#15-NA-016: Creak or Snap Noise Above Windshield from Removable Roof Lift Off Panel While Driving - (Sep 30, 2015)

Subject: Creak or Snap Noise Above Windshield from Removable Roof Lift

Off Panel While Driving

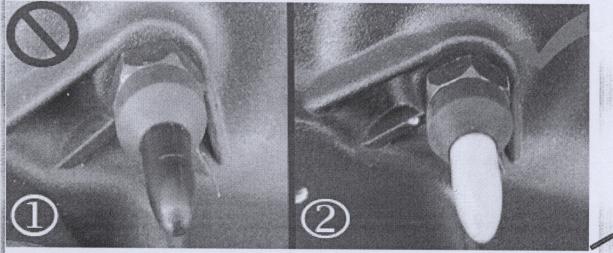
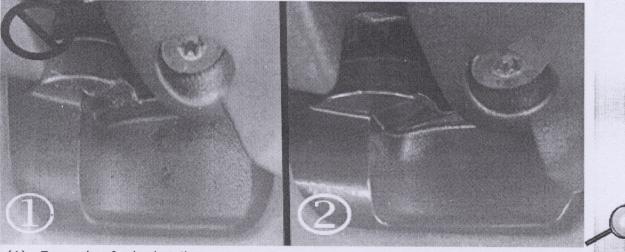
Condition	ne customers may comment on a creak or snap noise from the front of the ovable roof lift off panel while driving. The noise is more predominant when lient temperatures are high.	
Cause	This may be caused by a stick-slip condition between the front latches against the strikers and the front locating pins to the locating cup in the strikers.

- (1) Example of a bad front locating pin.
- (2) Example of a good front locating pin.

- (1) Example of a bad striker.
- (2) Example of a good striker.

If you encounter a vehicle with the above concern, replace both the front roof lift off panel strikers and both front locating pins. Refer to Roof Lift Off Panel/Window Front Striker Replacement and Removable Top Locating Pin Replacement in SI.
